SAGINAW CITY COUNCIL NOTICE OF SPECIAL MEETING

Consideration and Action regarding Change Order No. 2--Willow Creek Station Park Playground

CHANGE ORDER

PROJECT: Willow Creek Park Playground

POURED IN PLACE SAFETY SURFACING, TYP.

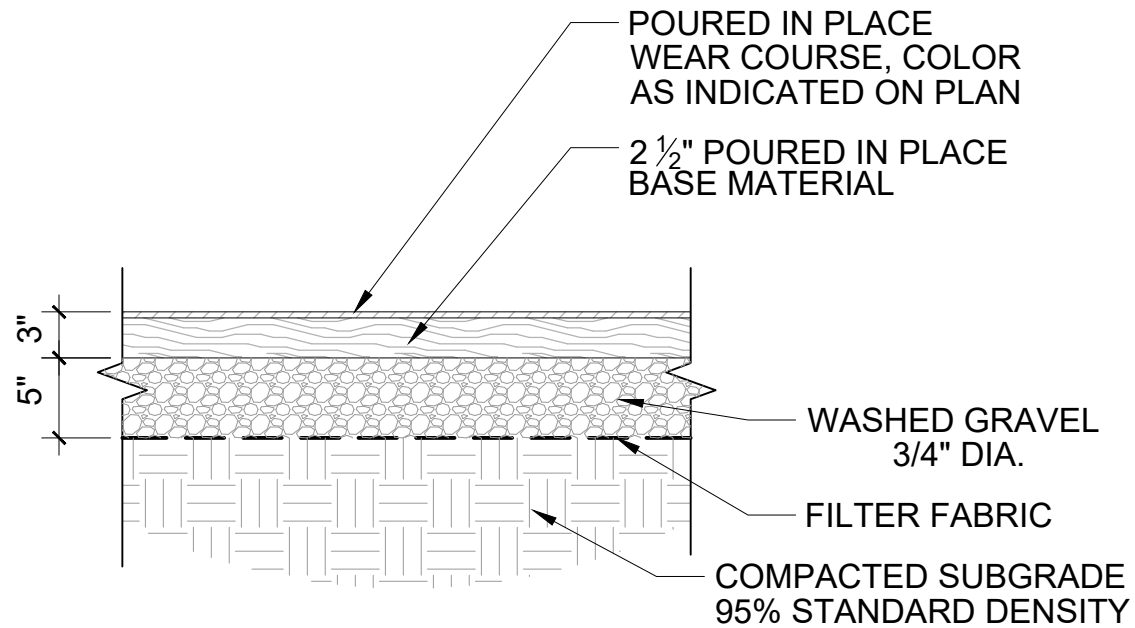
DESCRIPTION: Furnish and install 5" depth of ¾" washed gravel with woven filter fabric to be paid for by the City of Saginaw. GRod and GRod's subcontractors/vendors to remove existing poured-in-place (PIP) playground safety surfacing and select fill to accommodate washed gravel and install new PIP safety surfacing with 6"HDPE drains. la terra studio to review washed gravel and filter fabric submittals and visually observe the site prior to placement of filter fabric/washed gravel and PIP surfacing.
